Cards and security devices for personal identification — Contactless proximity objects —

Part 3: Initialization and anticollision

AMENDMENT 2: Enhancements for harmonization

Page 17, Figure 9

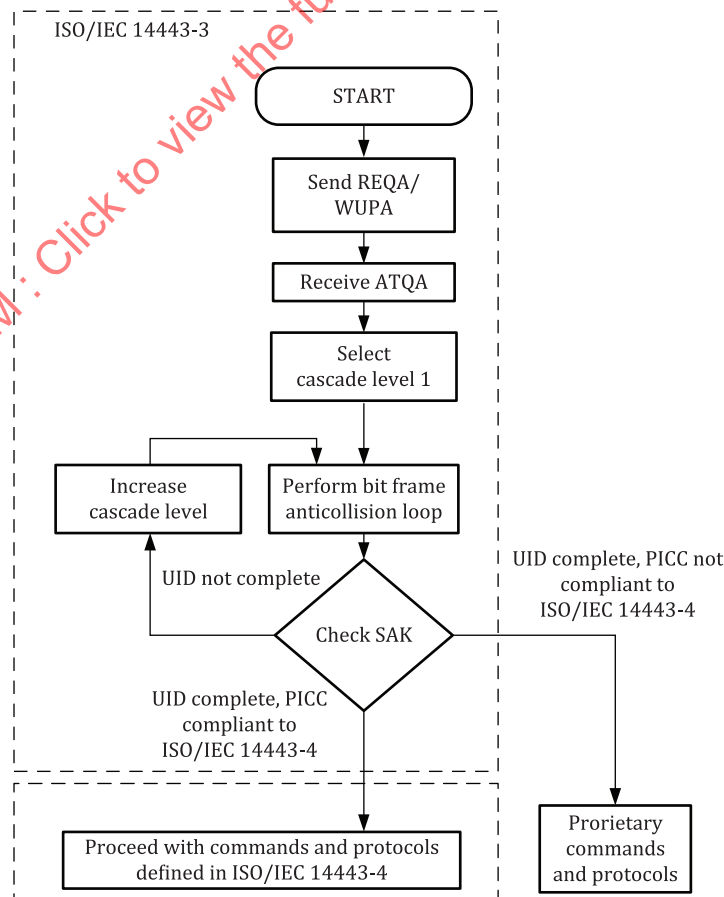
Replace "REQA" by "REQA/WUPA"; i.e. replace Figure 9 with the following figure:
